HF02 Redbud 2034 SW Farmfield Ln. Lee's Summit, MO

STRUCTURAL REVIEW HD ENGINEERING & DESIGN HD: 42618 DATE: 5/16/2022

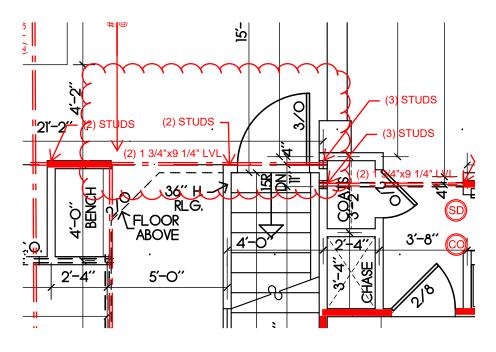
The framer has installed a (2) 1 3/4"X9 1/2" LVL between the Entry and Breakfast room instead of the planned W8X13 steel beam. After reviewing the code loading and spans our firm recommends approval of this alternate framing item as shown below.
